**STATE OF MAINE  
DEPARTMENT OF ENVIRONMENTAL PROTECTION  
BOARD OF ENVIRONMENTAL PROTECTION**

NORDIC AQUAFARMS, INC.  
Belfast and Northport  
Waldo County, Maine

**EXHIBIT NVC/UPSTREAM 10**  
TESTIMONY OF *MICHAEL LANNAN* WITH ATTACHMENTS

## BLASTING

**PRE-BLAST SURVEY DRAWING**

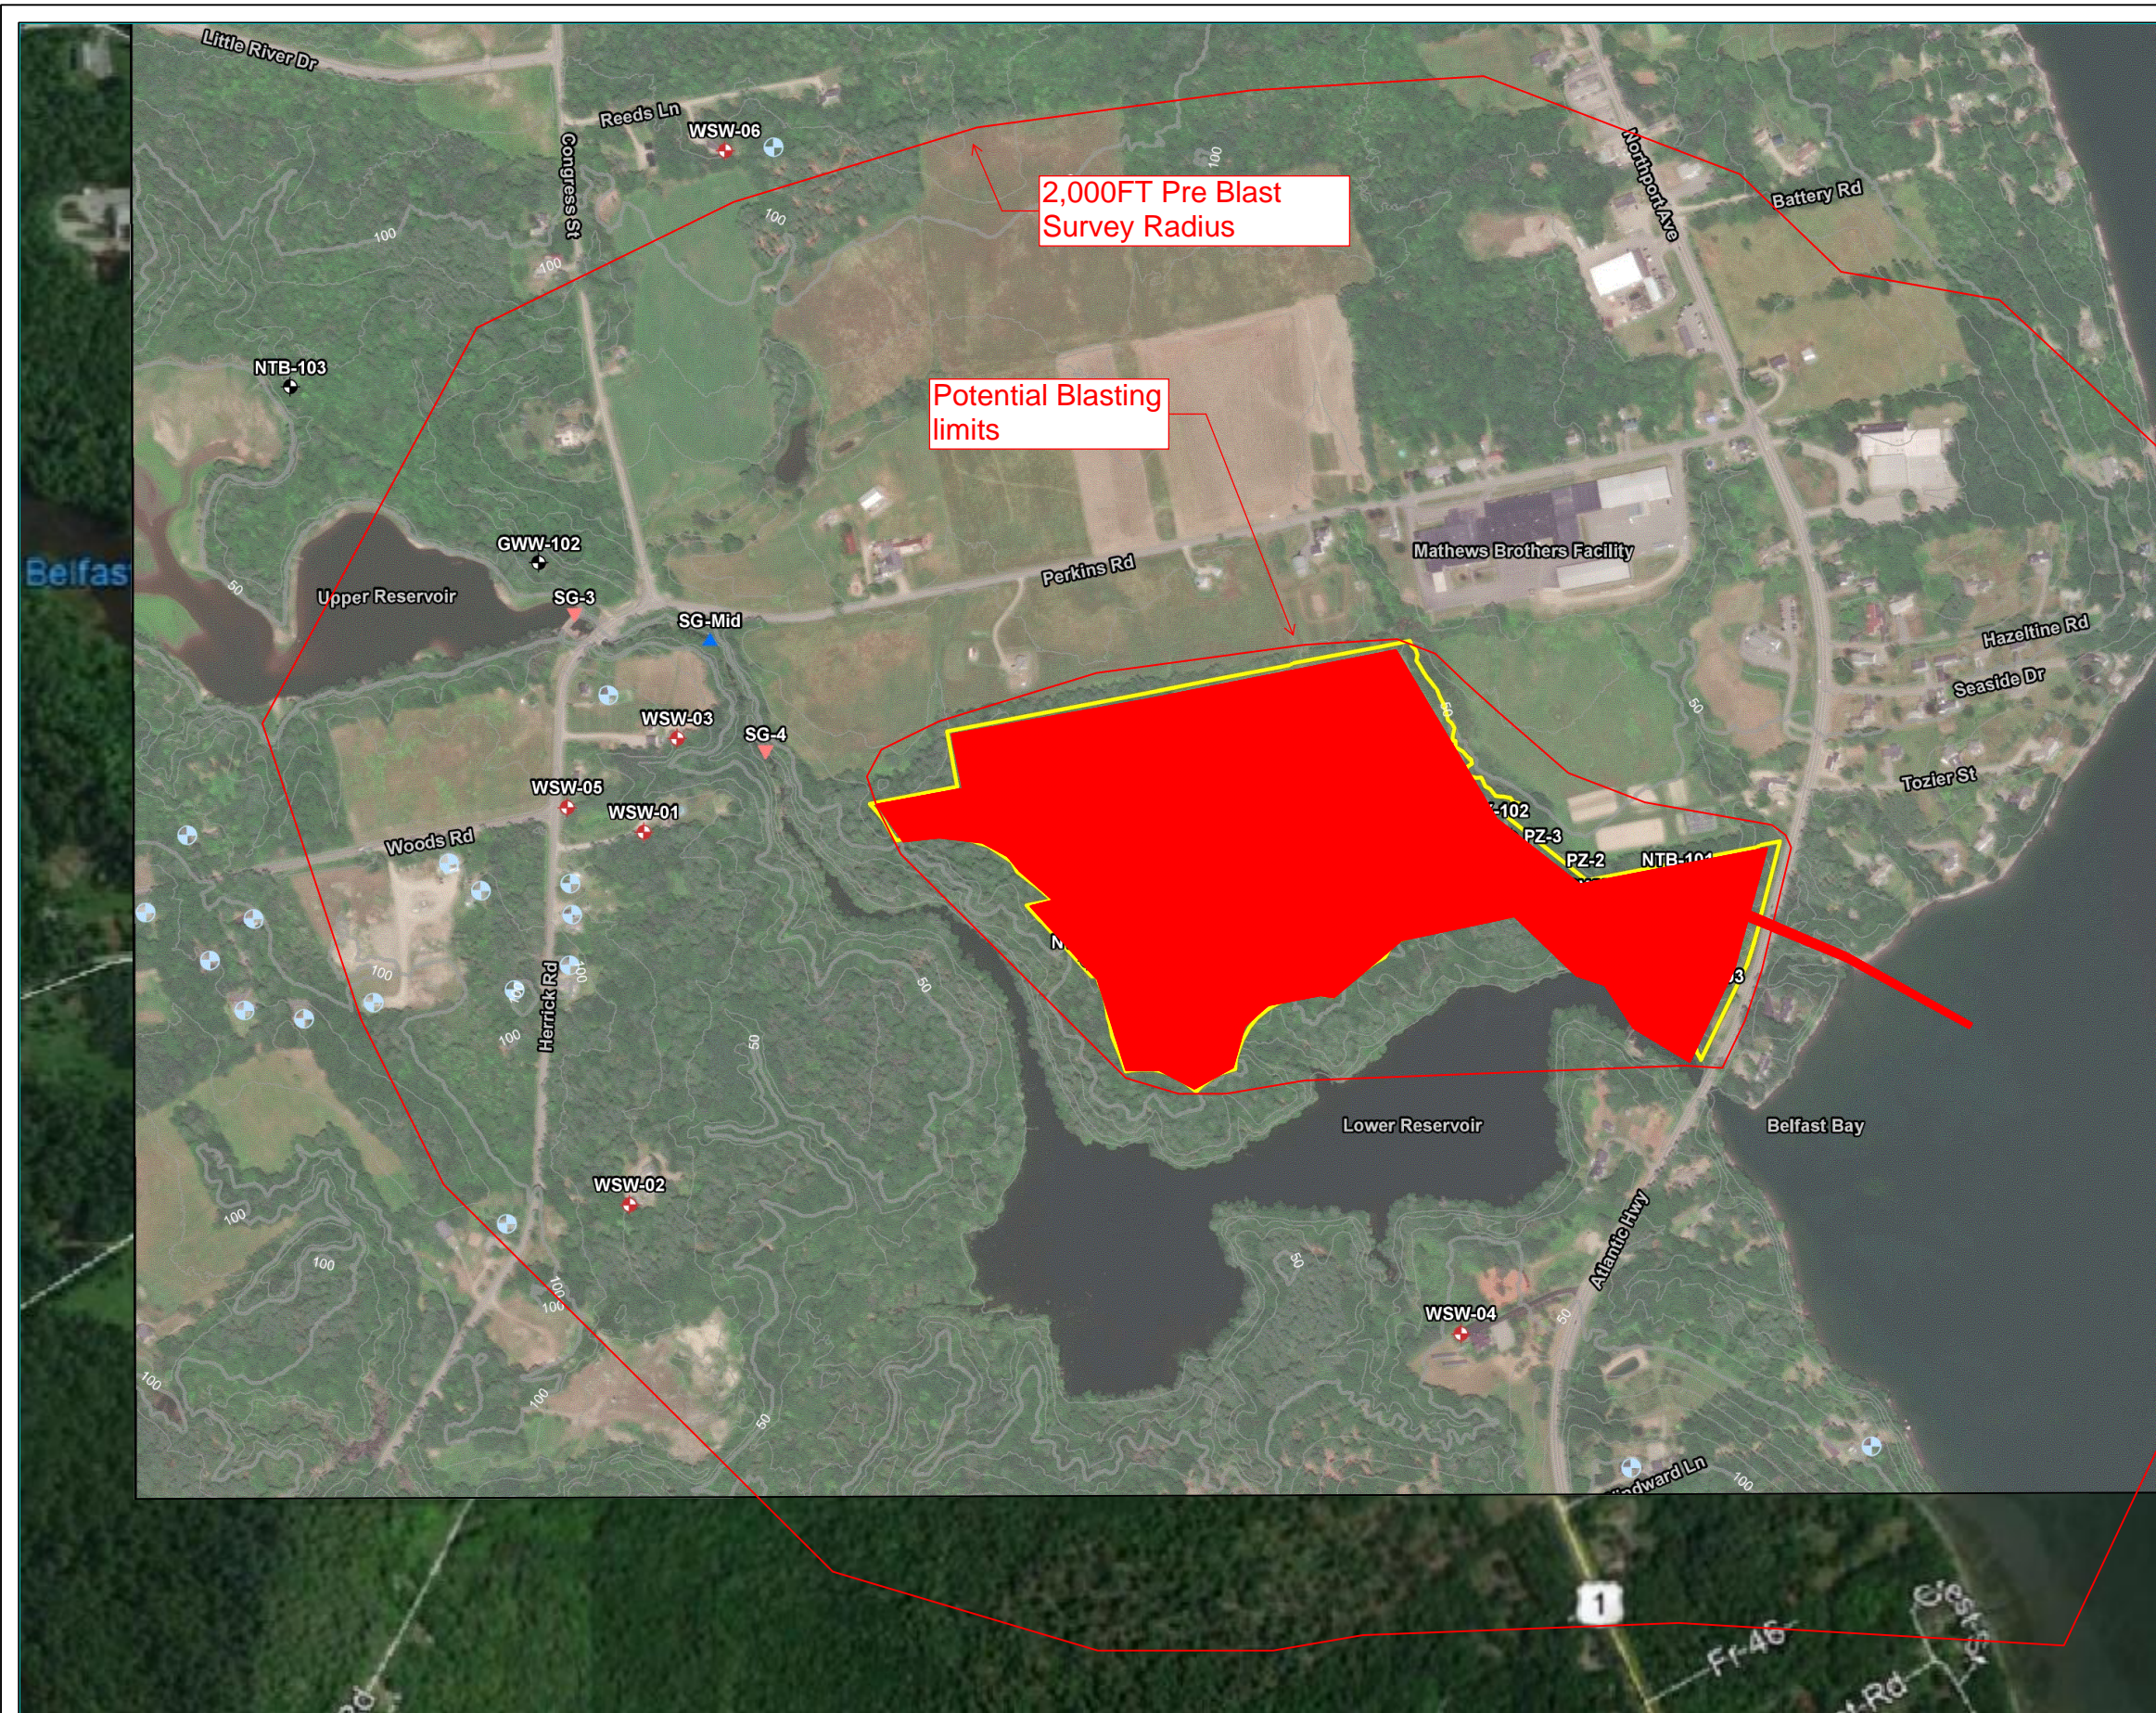
In the Blasting Plan prepared by Maine Drilling & Blasting, Inc. a Pre-Blast Survey Drawing was provided showing the project site, with an outline outside the project area, labeled as the “**Potential Blasting Limits**”. The limits are outside of the project site, and onto protected locations, and it is unclear what the drawing is trying to depict with outlining the potential blasting limits. That figure is included as Attachment A. Please note that according to this plan, blasting could occur adjacent to the existing lower dam structure. Both the lower and upper dams are old and in disrepair, water leaks through cracks in the upper dam during higher reservoir levels. Clearly, there is no “*Assessment of the potential for adverse effects of blasting on protected natural resources and structures* (i.e. the old dams).
